Access Compliance Report

Public Rights-of-Way

(Pedestrian Signals)

Intersection ID: N/A	Main Street:	Cross Street: N/A	Location: N/A
ADA ID: F988DBCDE78A	Signal Type: Two Push Buttons-Non APS	Overall Compliance: No	Severity Score: BTN 1:N/A BTN 2: N/A No BTN: N/A
Codes/Mitigation Info/Possible Solution		Field Measurements/Component Compliance

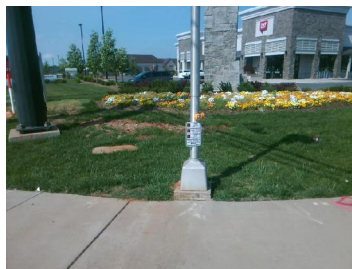
PROW/ADA: TMUTCD 4e.08, R406.2, R404.7.3

Yes	B 1 Clear Xing Direction?	ClearlyMarked	Yes	B 2 Clear Xing Direction?	ClearlyMarked
	B 1 Crossing Direction	To SE		B 2 Crossing Direction	To NE
Yes	B 1 DistanceTo XWalk (in)	0.0	Yes	B 2 DistanceTo XWalk (in)	28.0
No	B 1 DistanceTo Curb (in)	187.0	No	B 2 DistanceTo Curb (in)	172.0
Yes	B 1 Diameter (in)	2.0	Yes	B 2 Diameter (in)	2.0

Possible Solutions: Replace Signal Push Button With APS Button on New Post. Remove & Relocate Sign.
